# TECHNICAL BULLETIN

LTB00487v6  
09 JUN 2015

### 3.0 TDV6 Excessive Exhaust Smoke

**This version has been issued to add steps in the Service Instructions, pertaining to post-repair road test and the requirement for a regeneration of the Diesel Particulate Filter (DPF) if fitted.**

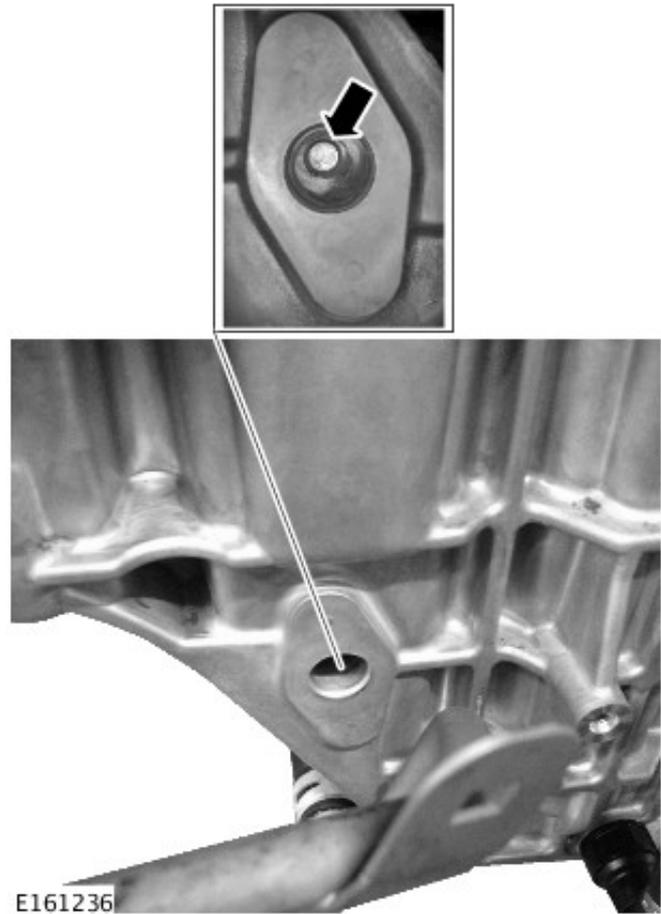
**NOTE: On vehicles post the closing VIN range stated on this bulletin the sump has been cast over and the blanking plate not fitted. See attached pictures. This is effective from engine number 0753185.**

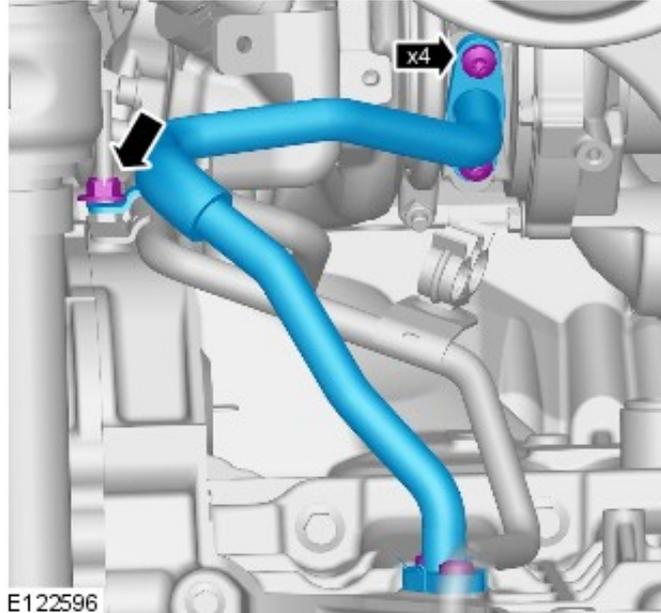
18. Remove and discard the oil drain tube.

- Position a suitable container to catch any fluids.
- Remove the 4 Torx bolts.
- Remove and discard the nut.
- Remove and discard the 2 gaskets.

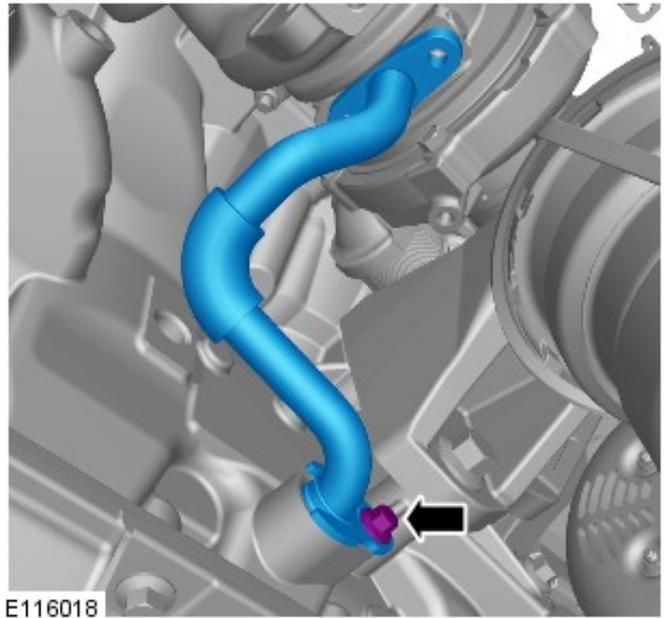
21.  **CAUTION: Make sure that the o-ring seal is correctly located on the oil drain tube.**

Install the new oil drain tube.

- Torque: 10 Nm

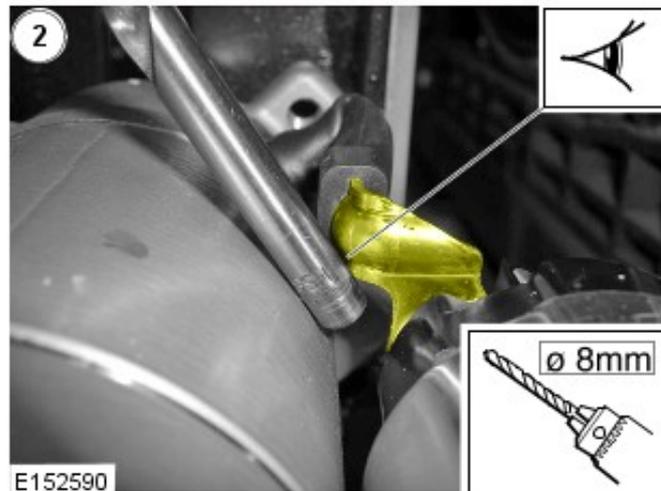
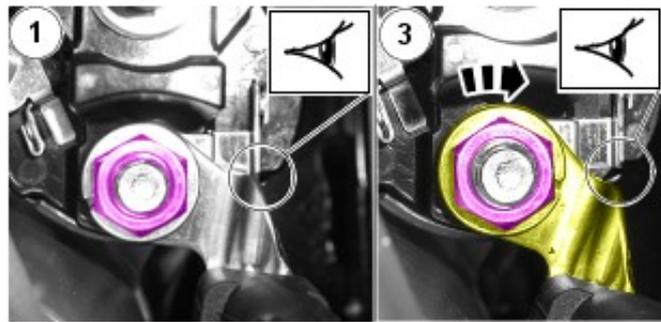
23.  **CAUTION: Make sure that the starter**

**motor cable is positioned as shown, failure to follow this instruction may result in damage to the vehicle.**

**NOTE: Use a 8mm drill bit to gauge the gap between the cable and the starter motor body.**

Adjust the position of the starter motor cable.

1. Slacken the nut.
2. Adjust the cable to achieve a 8mm gap between the cable and the starter motor body.
3. Whilst maintaining the gap shown, tighten the nut to 7 Nm.
